**BID: CPST-11
LOWCOUNTRY REGIONAL AIRPORT TERMINAL
RENOVATION & EXPANSION**

**Addendum #1
dated 3-15-2018**

***Mandatory Pre-Bid Meeting
Questions and Answers***

SECTION 1A
1"=1'-0" S4 | S10A

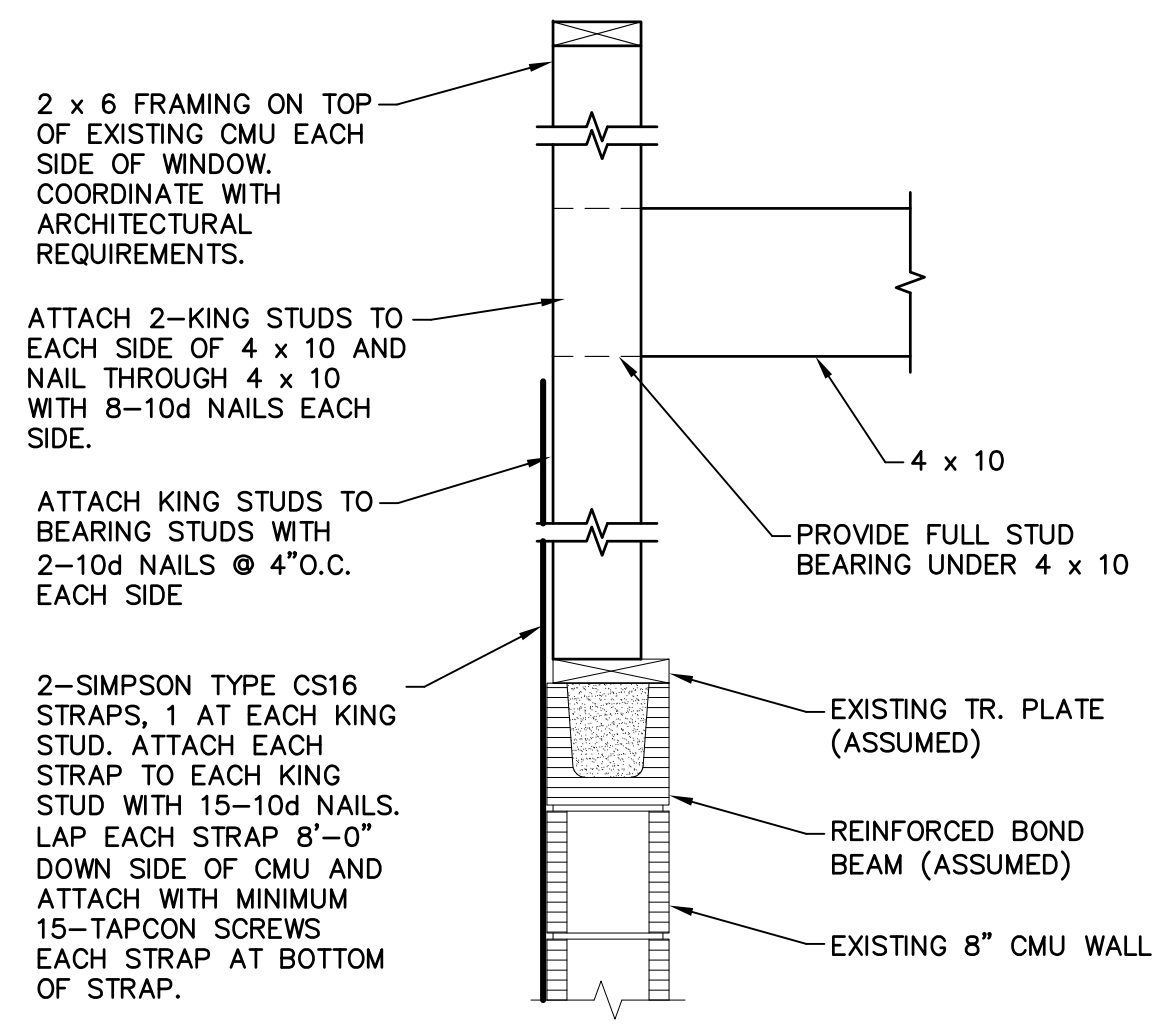
REVISED STRUCTURAL DRAWINGS:

- S4..... 1 sheet
- S5..... 1 sheet
- S9.....1 sheet
- S10 1 sheet
- S10A 1 sheet

1. Replace attached sheet(s) with the originally issued sheet(s) of the same number.
2. T1.00 – Replace Alternate 1 text with the following;
 1. PROVIDE 12" WIDE BRICK BORDERS AT PORCH PAVING IN LIEU OF 12" WIDE STAINED CONCRETE BORDERS, BASE BID PORCH AREA ONLY
